Application No.:	10/648,012
Applicant:	WOOLFORK, C. Earl
Filing Date:	08/26/2003
Title:	WIRELESS DIGITAL AUDIO MUSIC SYSTEM
TC/A.U.:	2615
Confirmation No.	3337
Examiner:	FLANDERS, Andrew C.
Docket No.	W003-4000

AFTER FINAL RESPONSE TO OFFICE ACTION

FIG. 3

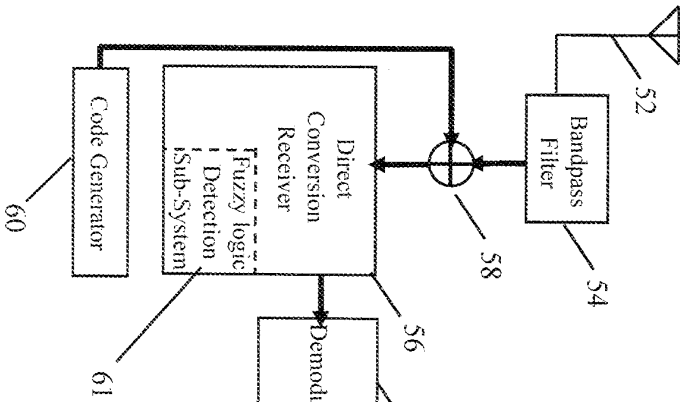
As stated above, Appellant has disclosed a form of fuzzy logic detection. However, Appellant has failed to explicitly show how it is implemented within the receiver of Figs.1 and 3. One of ordinary skill in the art would not know how or where to implement this fuzzy logic within the receiver 50 as disclosed in Fig. 3. There is not disclosure on where the sub system receives data from or what it outputs it to, only that it performs some operations on data.

impossible for one of ordinary skill in the art. **Undue experimentation** would be necessary to figure out exactly where it would need to be implemented as it is not sufficiently disclosed. Where exactly would one place this software or hardware within the disclosure of Fig. 3?

Figure 3 has been amended to include a fuzzy logic subsystem as is well described in the specification. Continuation paragraph [0011] states: "The fuzzy logic detection technique 61 that may be used in the receiver 50 could provide greater user separation through optimizing code division in the headphone receiver." Moreover, Continuation paragraph [0010] discloses "the spread spectrum modulated signal from transmit antenna 24 may be received by receiving antenna 52 and then processed by spread spectrum direct conversion receiver or module 56 with a receiver code generator 60 that contains the same transmitted unique code". Further support for the amendment is found in the Parent application (App. No. 10/027,391) (See Parent ¶ [0014]; ". . . a unique code word that spreads the signal spectrum.") Such amendment demands removal any 35 U.S.C. § 112 rejections for enablement of the instant invention. Because this element is found in both the Parent and instant application's specification, it does not constitute new matter.

in the text of the specification (See id.), Figure 3 has been amended to further demonstrate the placement of the fuzzy logic sub-system (Figure 3; 21).

Following the above rationale, the fuzzy logic subsystem would have to be located within the direct conversion receiver (DCR), and it would be apparent to one skilled in the art. Moreover by looking at Figure 3, the band pass filter passes the appropriate frequencies and then the DCR that follows has a DSP inside, the intended spread spectrum signal must be despread before any other action may occur. After the signal is despread, there is
